Colorado Smelter Superfund Site
Pueblo, Colorado

Early Interim Action Residential Property Cleanups
Operable Unit 1 – Community Properties
Record of Decision
September 2017

EARLY INTERIM ACTION RESIDENTIAL PROPERTY CLEANUPS OPERABLE UNIT 1 – COMMUNITY PROPERTIES

RECORD OF DECISION DECLARATION

Figure 2-1 Colorado Smelter Preliminary Study Area

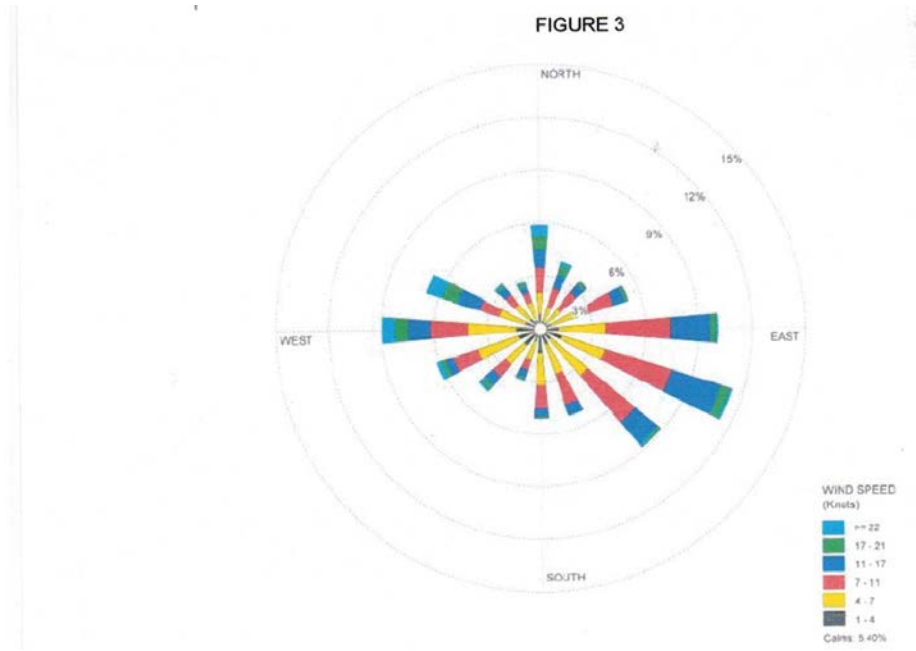
However, the study boundaries are shown in the following figure. EPA extend the site investigation boundaries significantly to the west and southwest, which is **into** the direction of the prevailing winds. The study area does include exclusively (few exceptions –please view the map) homes built before LBP was banned. This means that a significant lead source to soil is LBP, and EPA has guaranteed finding soil lead by establishing these boundaries, but does not allow characterization of historic deposition of particles from the closed smelter.

Figure 1. This is a composite of from the 2011 Analytical Results Report (Figure 3 - wind rows) and Figure 2-1 (The Study Area) from the 2008 Preliminary Assessment Report

Comparing the Study Area and the Wind rows figures, it is clear that the study boundaries were expanded to the west, which is dominated by older homes with LBP and is up wind (prevailing direction) of the actual smelter site.

Attachment 4:

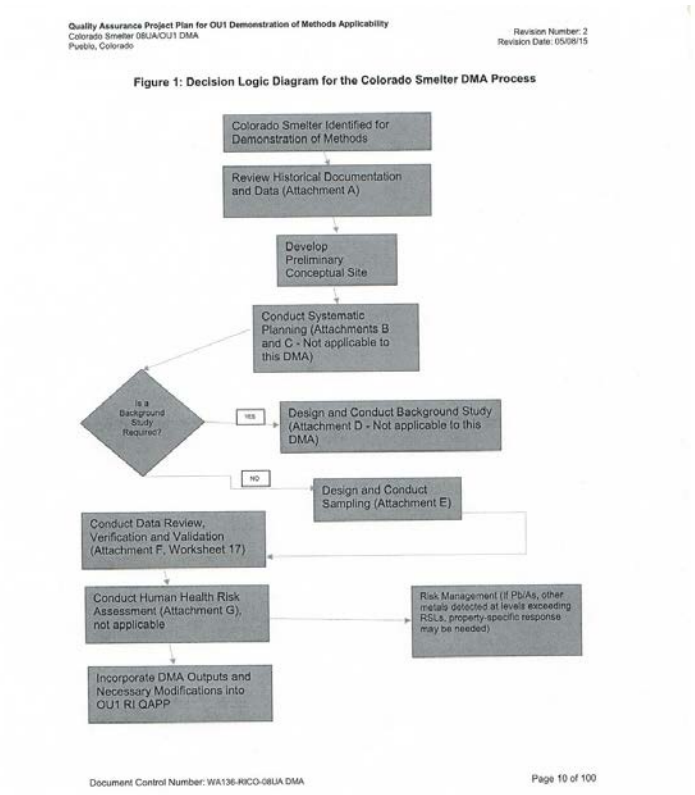
Attachment 4, which is Figure 1 of The DMA Quality Assurance Project Plan (QAPP) States that the DQO Process is "not applicable" to this project (my reproduction of that figure is poor and is given below.

It is my understanding that EPA guidance requires the DQO process to be performed any time samples are collected by EPA, EPA contractors, and subcontractors. I believe this is absolutely critical when the data are used to support decision-making.to support decision-making. If this is not correct, please provide quotes from EPA guidance to support the response.

Note that this was a popular approach (no DQO Planning) in the 1980's before the DQO process became guidance, but is not currently acceptable, unless EPA is exempt from following EPA guidance.

EPA Response: *The Demonstration of Methods Applicability (DMA) sampling design is outside the scope and detail of the Proposed Plan. However, the Data Quality Objective (DQO) systematic planning process was followed for both the DMA and the Remedial Investigation (RI) sampling efforts.*

The example referred to in the comment seems to be confusion caused by a note in a text block on Figure 1, which states "Conduct systematic planning (Attachments B and C – Not applicable to this DMA)."

This note was not intended to imply that systematic planning is not applicable to the DMA, rather it was intended to communicate that Attachments B and C are not applicable. Page 8 of 100 in the DMA QAPP explains that "Figure 1 is a summary flowchart that outlines this DMA process. ***Where applicable****, the figure is supported by a series of attachments that provide additional detail on the project activities to be performed at key milestones of the project." (bold added for emphasis). Not applicable in the text box indicates that the DQO process is not documented in Attachments B and C, nothing more.*

As indicated on page 13 of the DMA QAPP, Attachment B, when applicable, would contain the systematic planning meeting agenda, and Attachment C would contain the CSM (conceptual site model) and data gap assessments conducted during systematic planning. Attachment B, the agenda(s) for the systematic planning meetings held on February 27, 2015 and March 24, 2015 (documented in the DMA UFP-QAPP, Worksheet #2, #9a and #9b) was listed as not applicable because a formal agenda was not prepared in advance of these meetings. Attachment C was listed as not applicable on Figure 1 because the CSM is provided on DMA QAPP Worksheet #10, instead of as a standalone attachment to the document. We apologize for the confusion. The EPA agrees with the commenter that "just collecting data to see what it tells us" is an unacceptable approach.

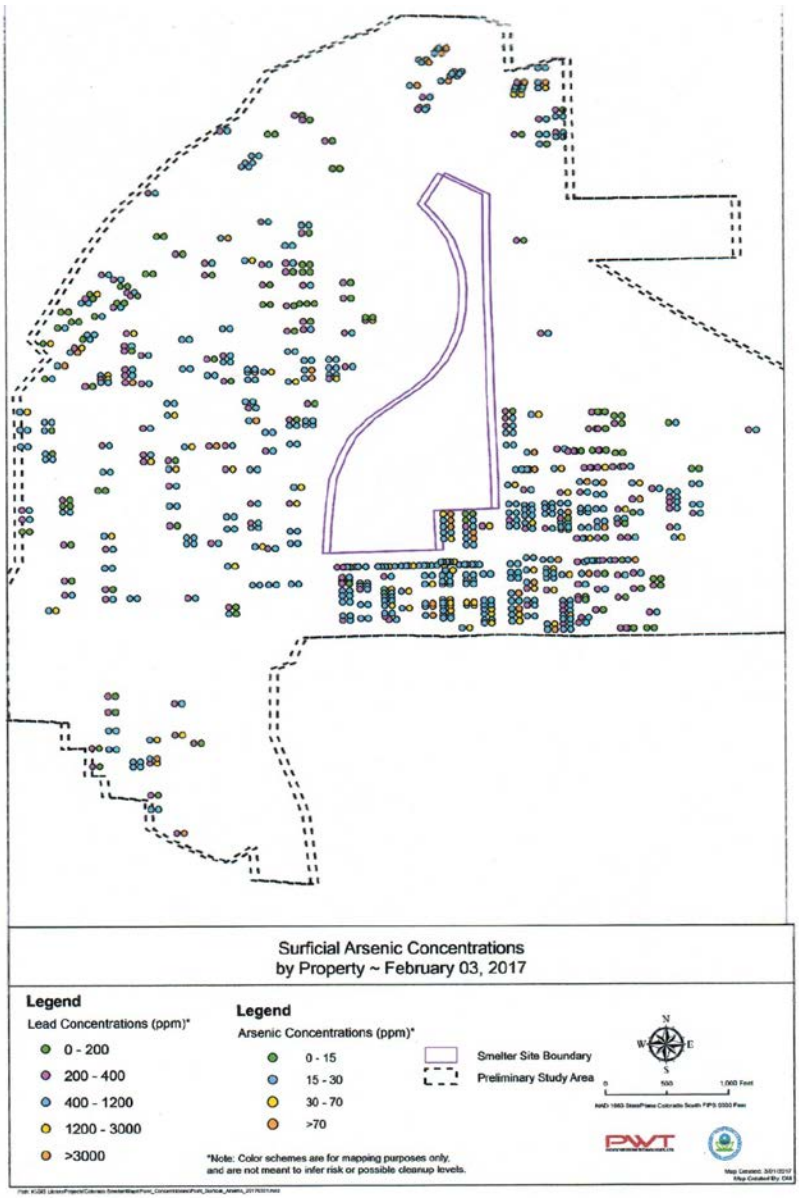
As detailed below, the Colorado Smelter Superfund project has not included: "good science", nor followed EPA Guidance.

The DQO planning guidance was stated as "not applicable" in the initial report, and the interim results are based on assumptions that are not supported by the EPA-collected data. For example, it was assumed by EPA that lead and arsenic originated from a point source – the Colorado Smelter. If that were true, the soil lead and arsenic concentrations should decrease with distance from the source. EPA supplied two large illustrations for the CAG (Community Advisory Group) displaying the soil arsenic and lead concentrations in the investigations area. I combined the two maps so the relative lead and arsenic concentrations could be visually compared. This is shown below. When this figure is examined, it appears that the lead and arsenic concentrations are not related to each other and are not likely from a single source such as smelter stack emissions. EPA provided pdf copies of those documents. The copies were combined into one document so side-by-side visual comparisons could be made. That combined figure is shown below:

A review of the combined figure led to examining the correlation coefficients for all the metals with reported concentrations. The correlation coefficients are reported below:

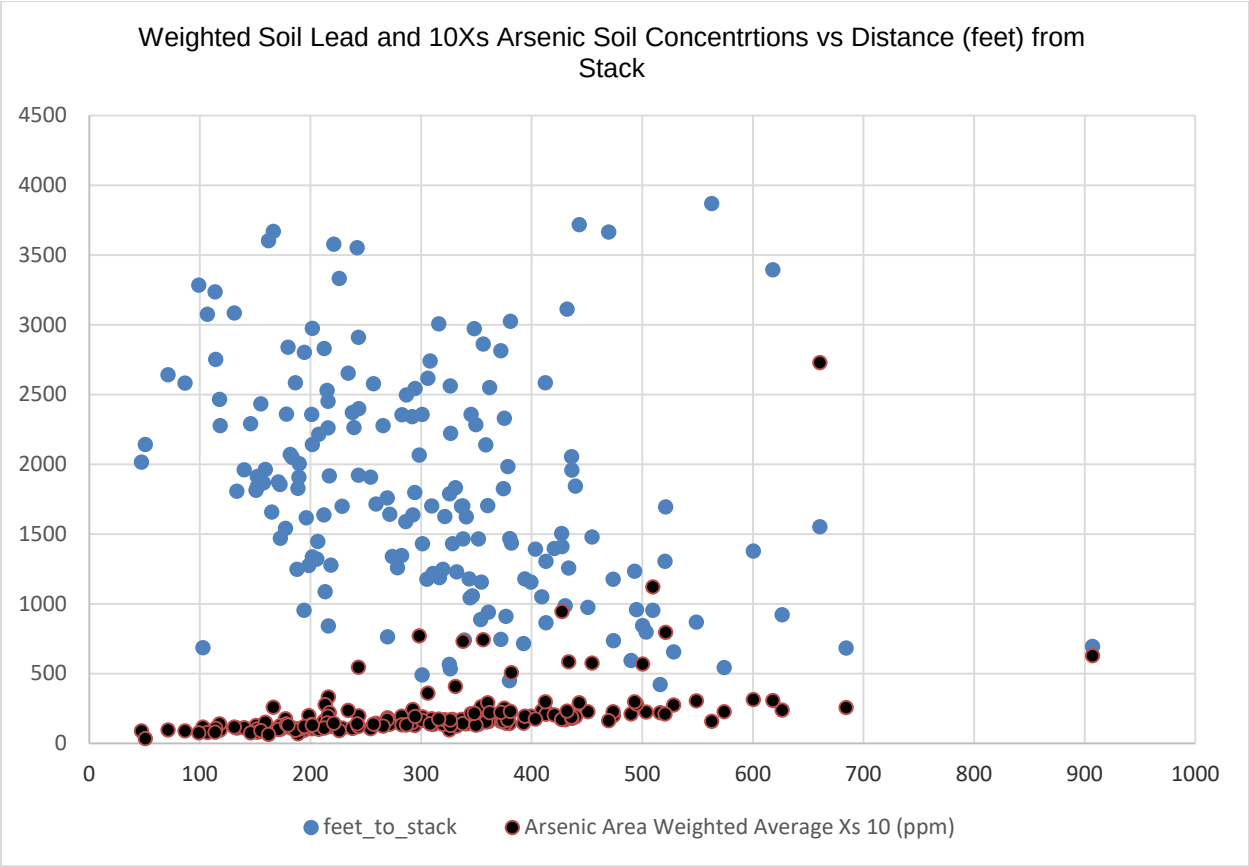
EPA supplied distances from the primary stack, and weighted average lead and arsenic concentrations for each yard. When those data are plotted (weighted average soil lead and arsenic) versus distance from the stack, The following plot is obtained:

The above plot documents that the soil lead concentrations are not dependent on distance from the smelter and that the weighted average soil arsenic concentrations actually increases with distance from the smelter.

It is concluded that particulate arsenic from the smelter stack is not source of arsenic to the investigative area soil.

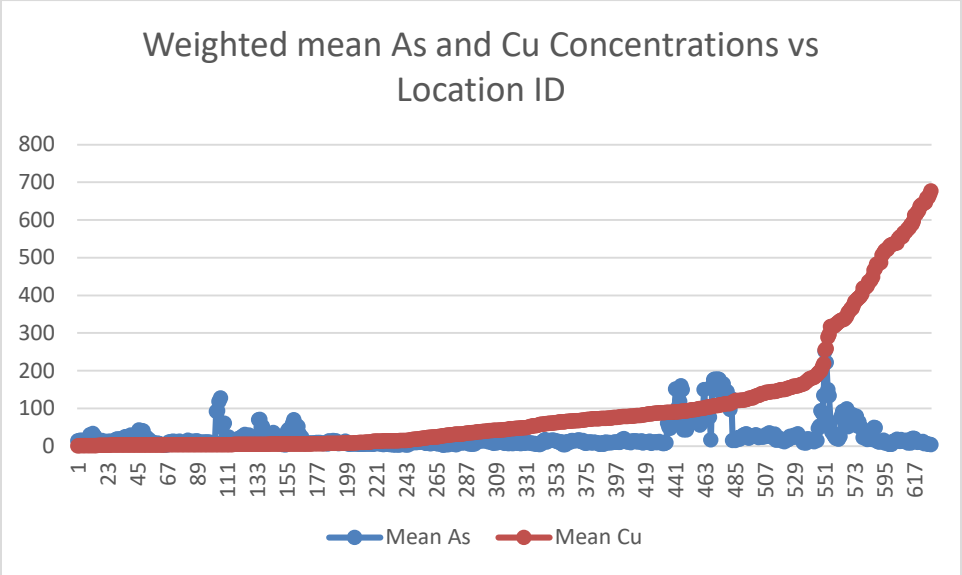
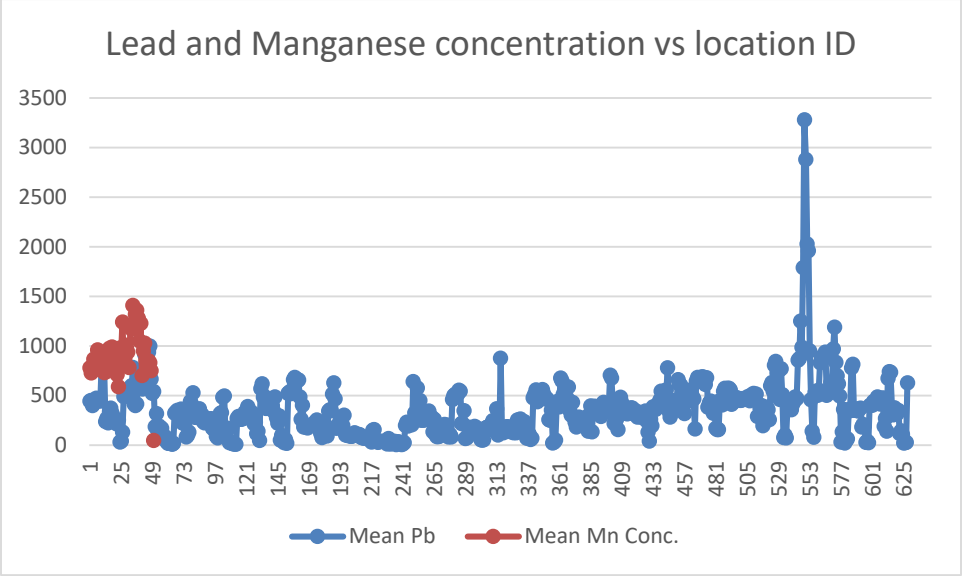
EPA should plot the locations of Cu and Mn concentrations to identify the potential contributions to soil. This is very difficult to do, since EPA has declared that addresses are confidential and cannot be shared with the public. Perhaps Longitude-Latitude information could be shared and then the data could be plotted over the area. Given sufficient time and effort, I should be able to furnish those plots if EPA chooses not to do so**.**

The following graphs show that copper concentrations increase with increasing property number and that manganese are increased at low property numbers.

<u>REQUEST</u>: Please evaluate all of the metals concentrations and plot them in order to identify potential sources of the metals other than assuming it was due to the historic smelter. In addition, EPA, please

supply latitude and longitude data for the sampled locations. This will keep the addresses "confidential" as you have declared is EPA guidance or policy and allow the public to evaluate the data.

Figure 2

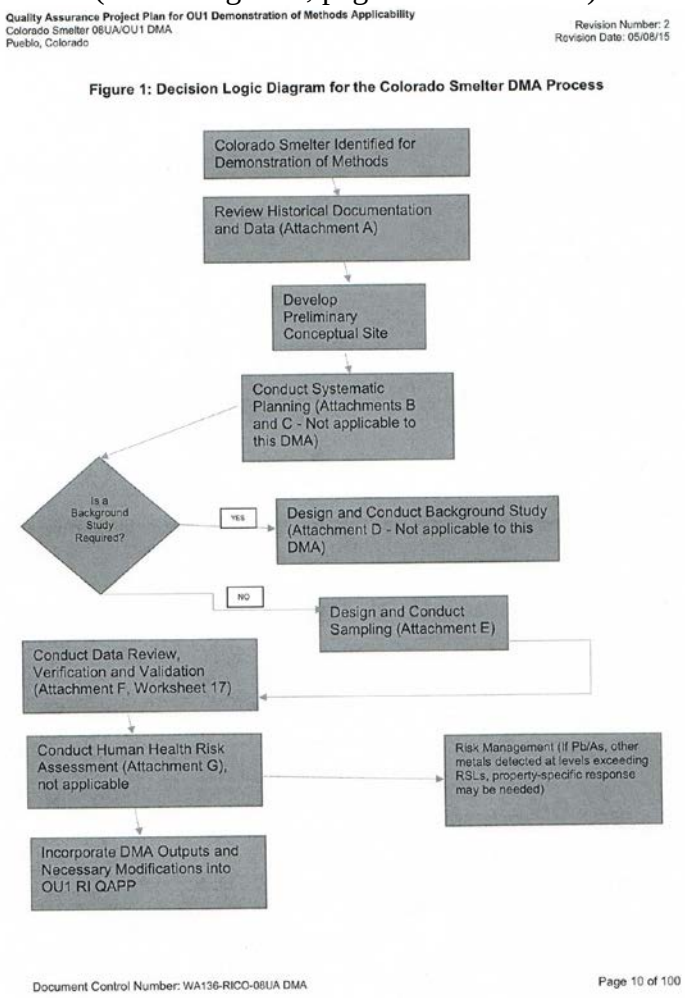
EPA has specific guidance related to Project Planning. It is called the Data Quality Objectives (DQO) planning Process. Project Planning has not been performed or documented in this project, which is required according to EPA DQO guidance. In fact, the DMA report (Demonstration of Methods) states in Figure 2, shown below: that the DQO Process is not applicable.

A simple critique is that the quantity and quality of data required to support decision-making was not identified, the actual decisions to be made were not defined, the acceptable uncertainty in the decision

was not defined and the quantity and quality of data was not defined. When questioned about future data, EPA simply states that "more data are needed". I can supply many specific comments for consideration Mr. Pruitt's staff.

EPA Response**:** *The Demonstration of Methods Applicability (DMA) sampling design is outside the scope and detail of the Proposed Plan. However, the Data Quality Objective (DQO) systematic planning process was followed for both the DMA and the Remedial Investigation (RI) sampling efforts. The issue referred to in the comment seems to be confusion caused by a note in a text block on Figure 1, which states "Conduct systematic planning (Attachments B and C – Not applicable to this DMA)."*
This note was not intended to imply that systematic planning is not applicable to the DMA, rather it was intended to communicate that Attachments B and C are not applicable. Page 8 of 100 in the DMA QAPP explains that "Figure 1 is a summary flowchart that outlines this DMA process. ***Where applicable****, the figure is supported by a series of attachments that provide additional detail on the project activities to be performed at key milestones of the project." (bold added for emphasis). Not applicable in the text box indicates that the DQO process is not documented in Attachments B and C, nothing more.*

As indicated on page 13 of the DMA QAPP, Attachment B, when applicable, would contain the systematic planning meeting agenda, and Attachment C would contain the CSM (conceptual site model) and data gap assessments conducted during systematic planning. Attachment B, the agenda(s) for the systematic planning meetings held on February 27, 2015 and March 24, 2015 (documented in the DMA UFP-QAPP, Worksheet #2, #9a and #9b) was listed as not applicable because a formal agenda was not prepared in advance of these meetings. Attachment C was listed as not applicable on Figure 1 because the CSM is provided on DMA QAPP Worksheet #10, instead of as a standalone attachment to the document. We apologize for the confusion. The EPA agrees with the commenter that "just collecting data to see what it tells us" is an unacceptable approach.

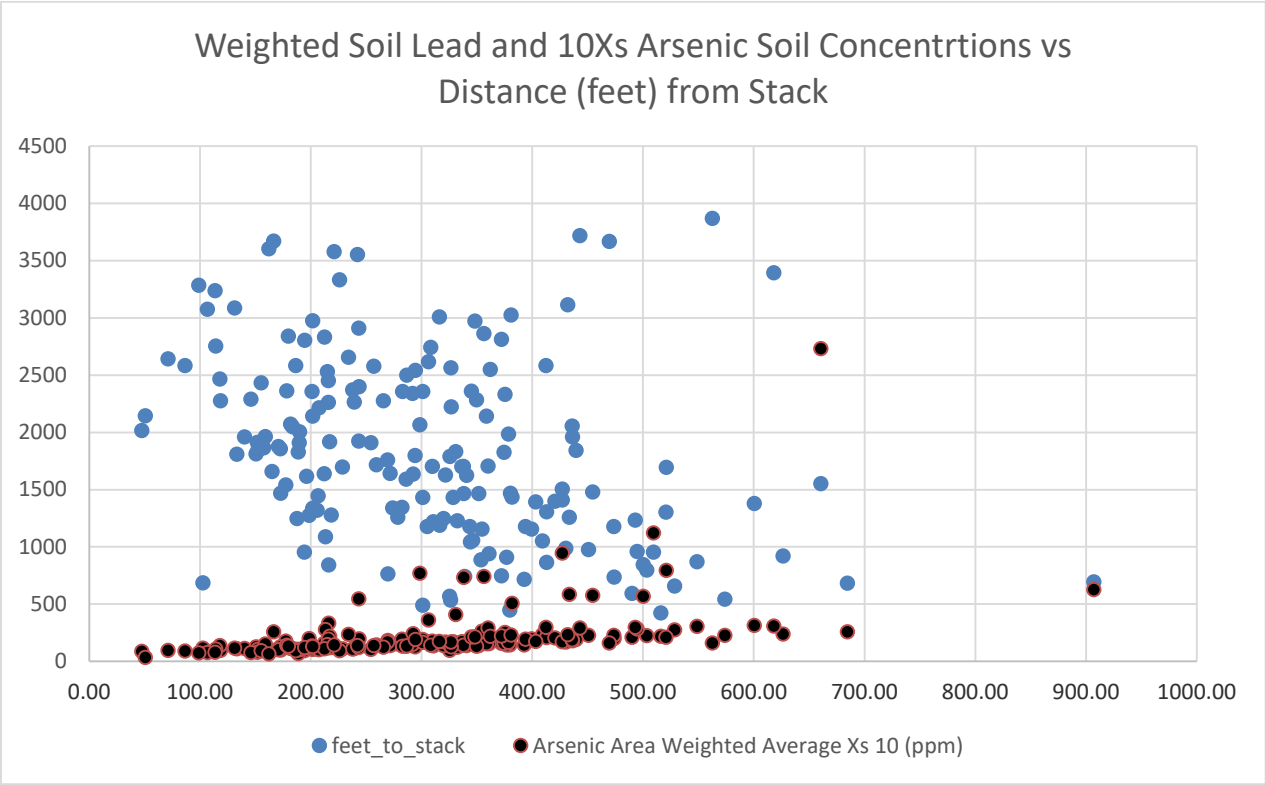
The following Figure (Weighted soil Lead and 10Xs Arsenic Soil Concentrations vs Distance (feet) from Stack) displays the area averaged lead concentration for yards sampled versus distance from the stack. The soil lead concentrations and distances from the "primary or tallest stack" are for individual yards were provided by EPA R8. It is true that this this single tallest stack was not the only smelter source of contamination, however, this analysis is applicable to all smelter sources because of their proximity within the smelter area. Note that the combined sources (including fugitive emissions) would have been disbursed in a similar manner. The weighted average arsenic concentration has been multiplied by 10 in order to display any trends. Otherwise, the arsenic data would be a nearly straight line at the bottom of the figure and concentration trends would not be detectable. This figure and the data show that the weighted average soil arsenic concentration actually increase with increasing distance from the smelter (stack). This analysis demonstrates that the smelter is not a major source of soil arsenic in the study area and that other arsenic sources (herbicides, pesticides, and Paint) are the contributors of arsenic.

The weighted soil lead concentrations do not show an expected trend of lower concentrations with increasing distance from the smelter stack. This not unexpected, since the study area contains many very old homes built before LBP was banned. These data support position of soil lead data taken from an area of older homes.

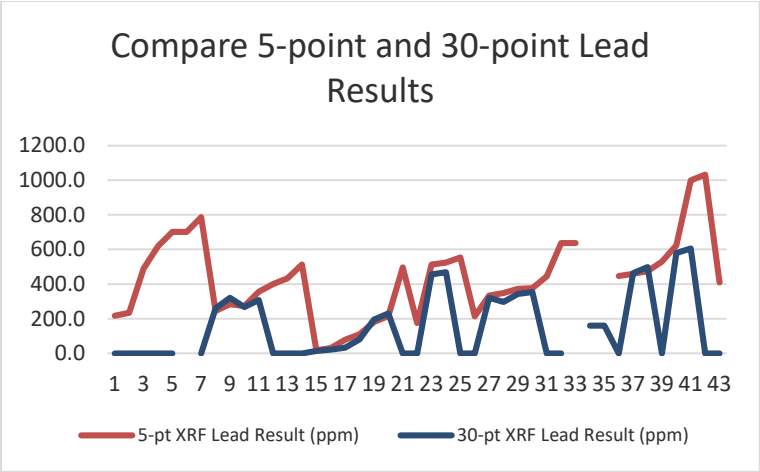
> Judgmental (or Samples collected in areas suspected to have higher contaminant authoritative) samples concentrations due to operational or historical knowledge. Judgmental samples **cannot** be extrapolated to represent the entire site.
>
> Note that judgmental samples were extrapolated to entire areas, including parks.
>
> Early in the investigation EPA released comparative data for 30-point and 5-point sample data (these data are reproduced in Attachment XX
>
> Graphic comparisons, below, of the data for lead concentrations do not appear to show good agreement between the lead concentrations in 30- and 5-point samples:

I Request that EPA statistically and graphically compare all available 5- and 30-point sampling data to demonstrate that they are equivalent, as stated in their reports.
